Junction Creek Subwatershed Study and Stormwater Master Plan

**Subwatershed Management Strategies
Recommended Preferred Solution**

**Public Meeting No. 4
March 21 and 22, 2018**

Written submission – Junction Creek Subwatershed Study and Stormwater Master Plan (PIC 4)

Dredge Junction Creek Downstream of the Ponderosa

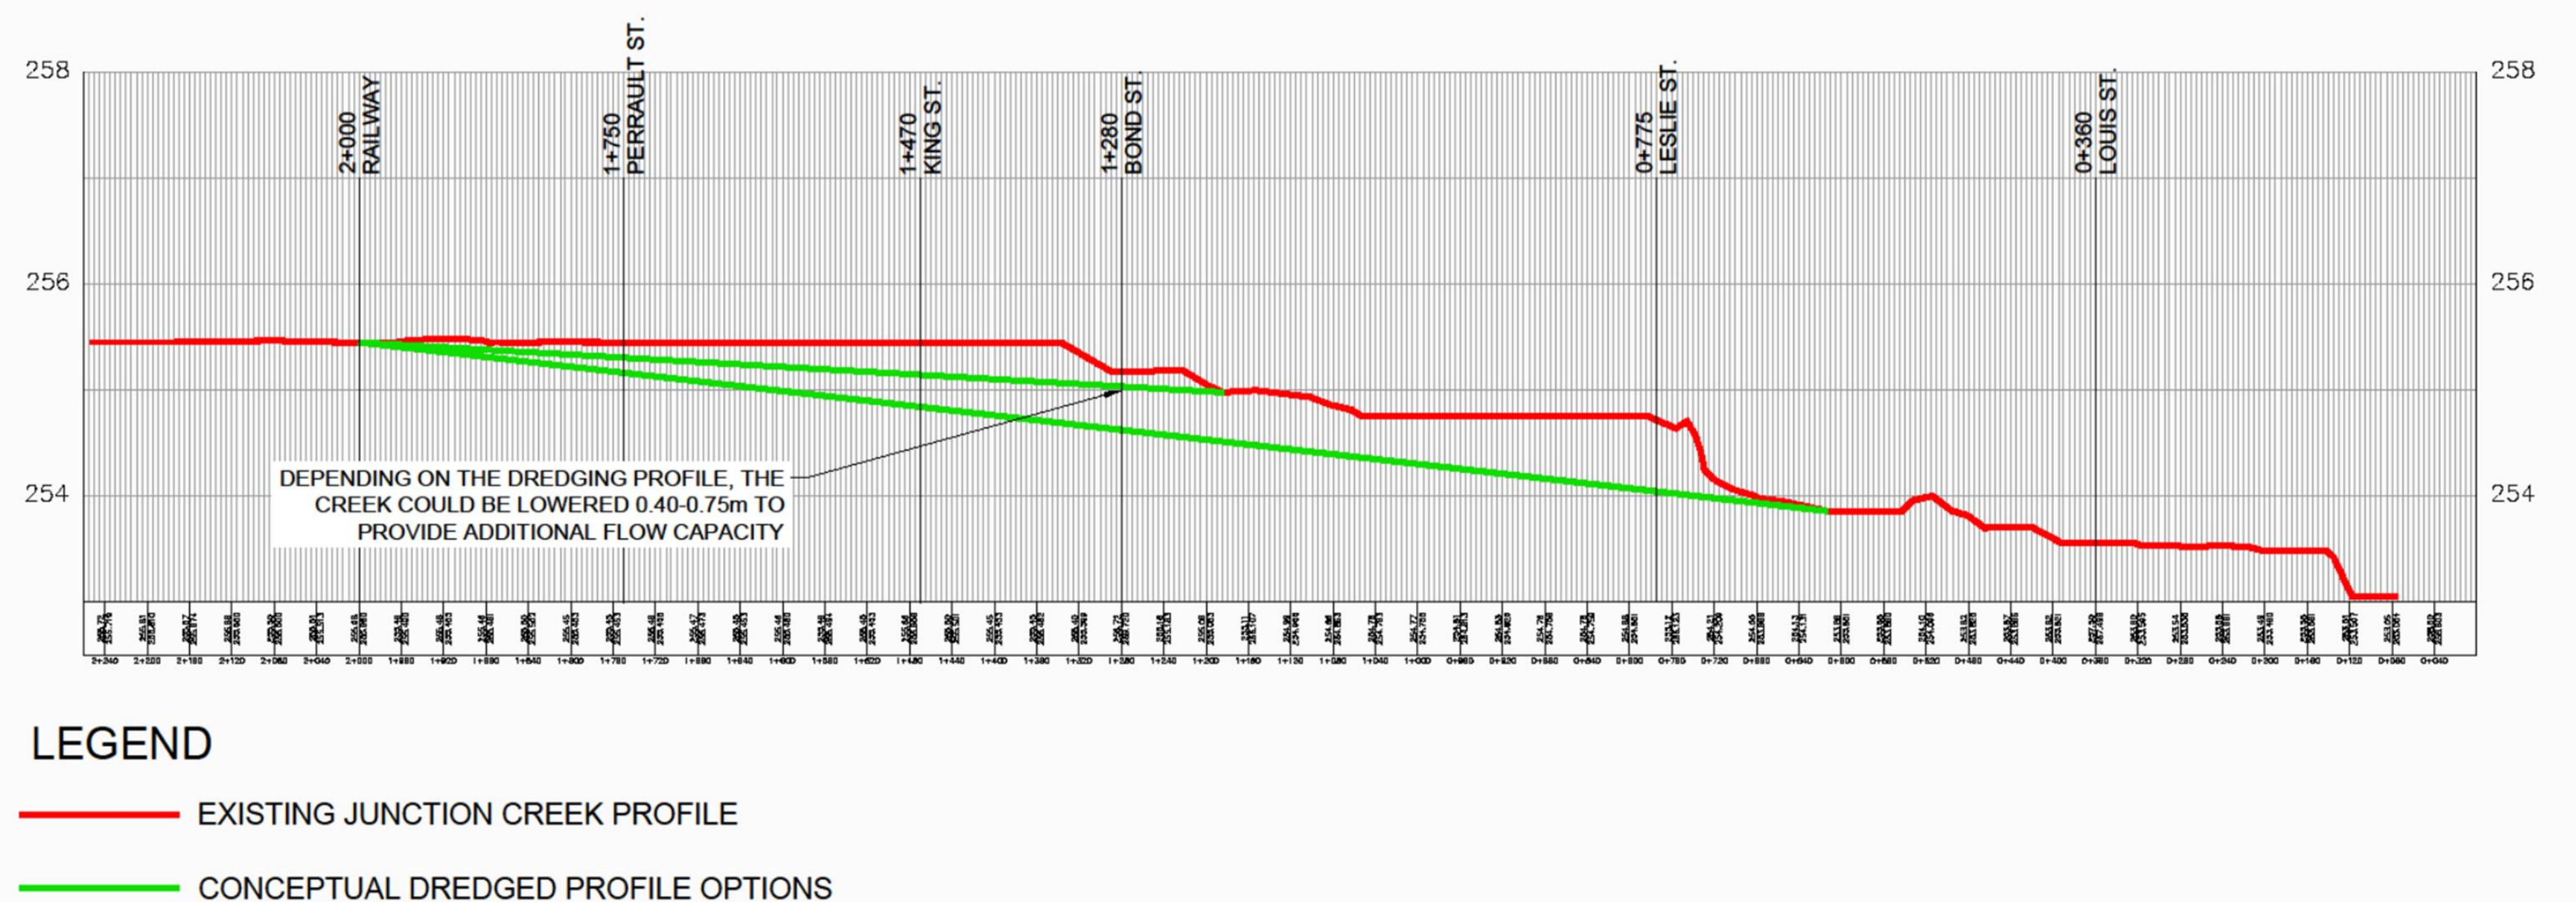
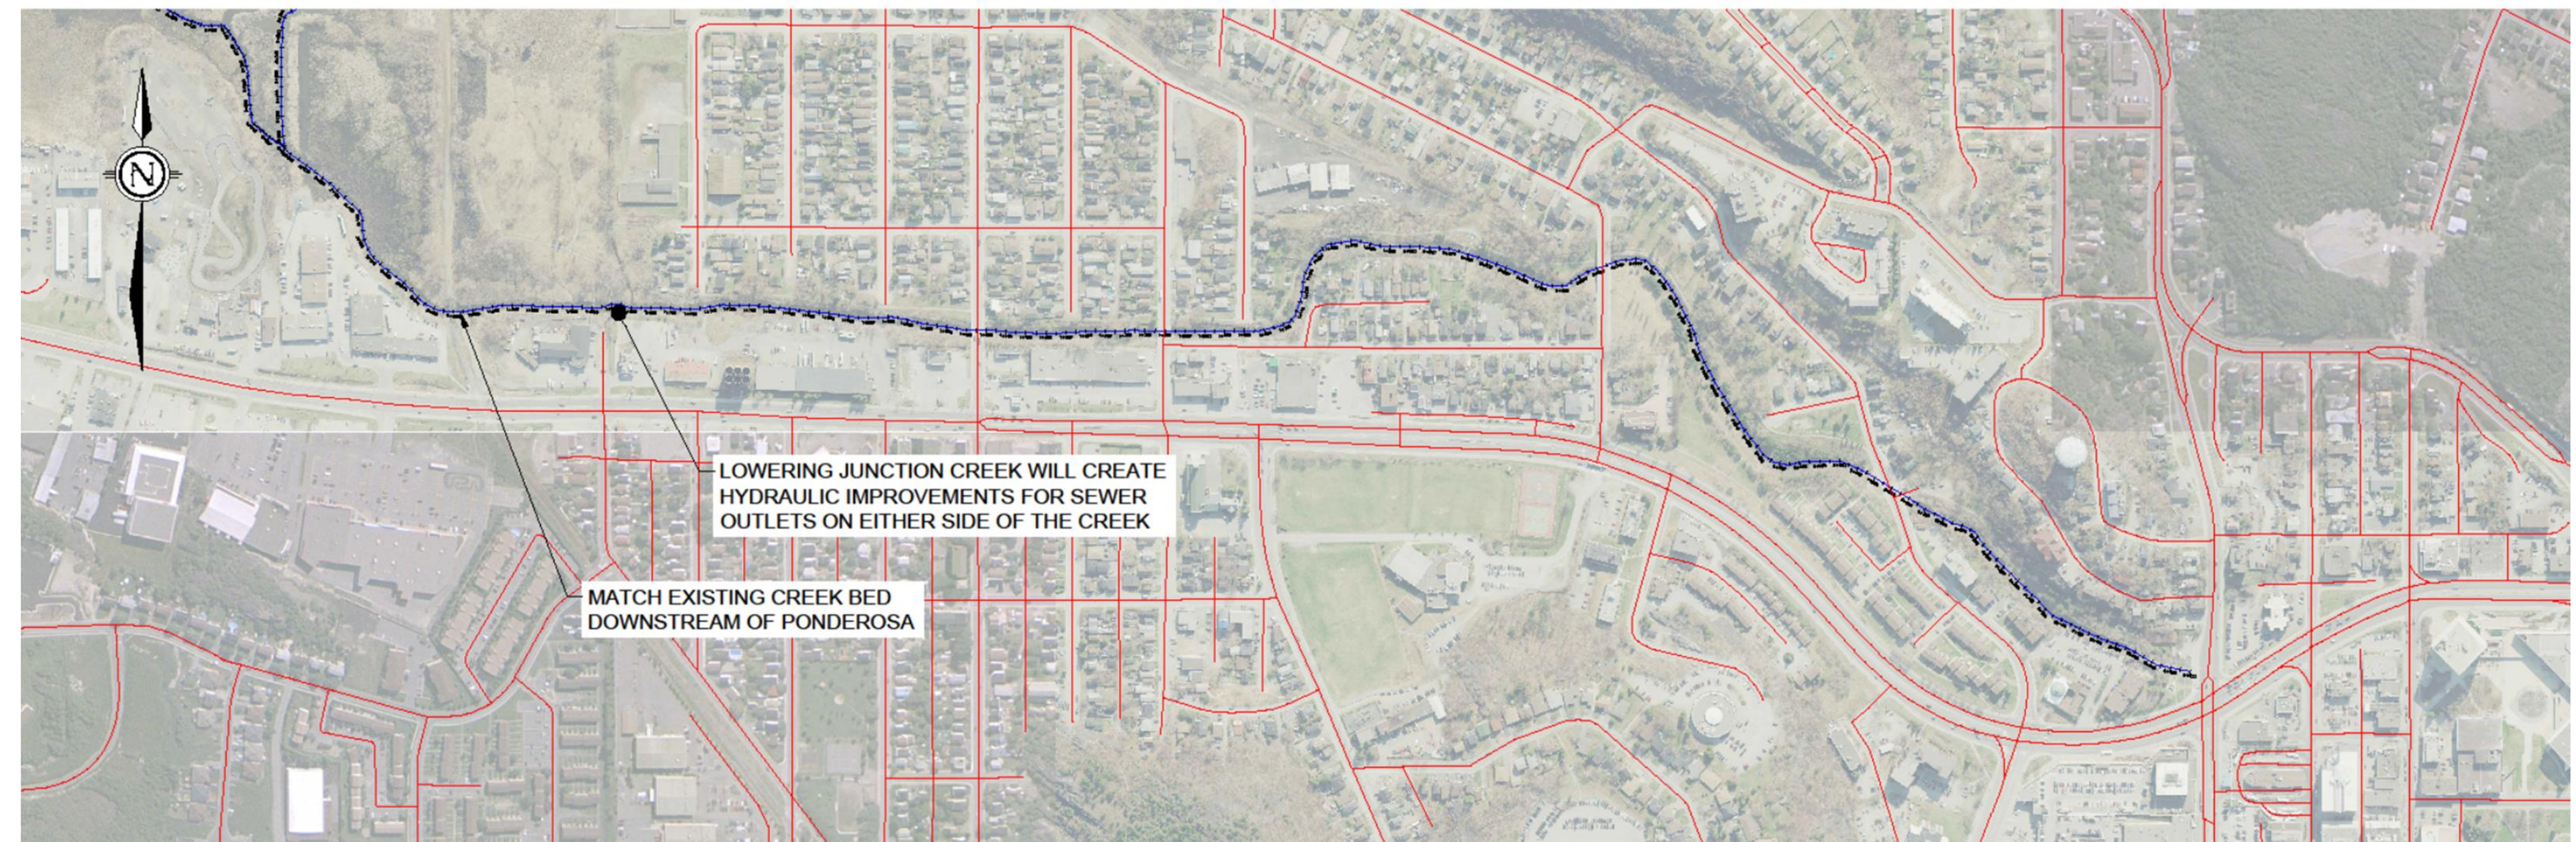
- *Alternative 9. Improve the Conveyance Capacity of Junction Creek.* Dredging of Junction Creek is also proposed downstream of the Ponderosa wetland, so that the creek can carry more water. Dredging the creek will remove any natural restoration of the creek bed, which would take many years to recover to the same stage. Causing more and faster water will also aggravate

creek bank erosion. Finally, it will make the creek more dangerous as it runs through the Flour Mill, which is arguably an unacceptable risk for families in the area.
